AGENDA
Design Review Committee
November 8, 2023 – REGULAR MEETING

Town of Jackson Design Guidelines Checklist

Item Number: P23-175

Response to Town of Jackson DRC Comments dated 2023 September 26

A2 GUARDRAIL @ RETAINING WALL

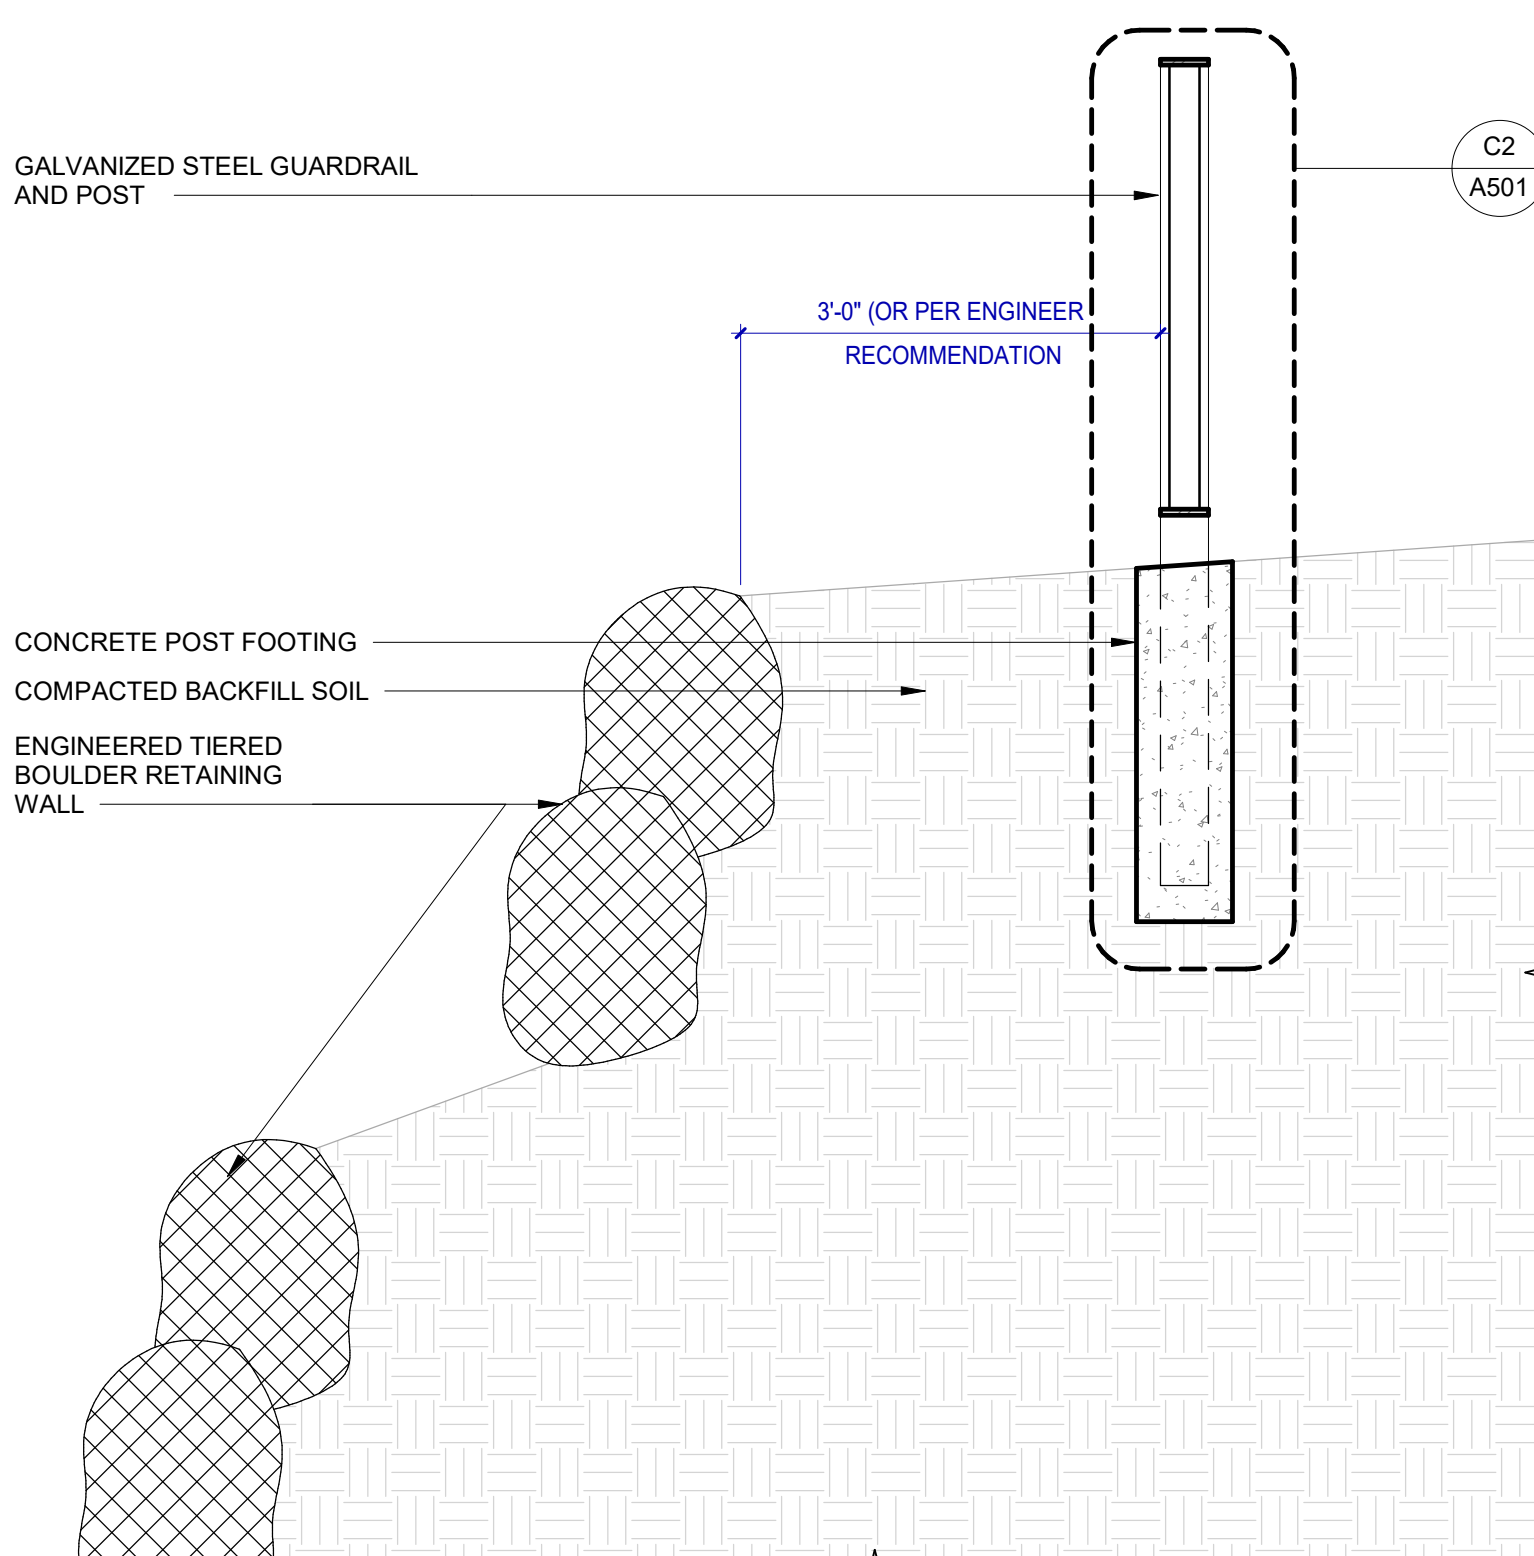
- d. Provide more details on the dry-stack boulder wall along the southern portions of the property.

Response: Boulder wall details are provided on sheet C13 and sheet A501.

- Provide more details on the dry-stack boulder wall along the southern portions of the property. **See boulder wall detail 1 on sheet C113 and detail A2 on A501. Also, see the attached guardrail/ boulder wall exhibit.**
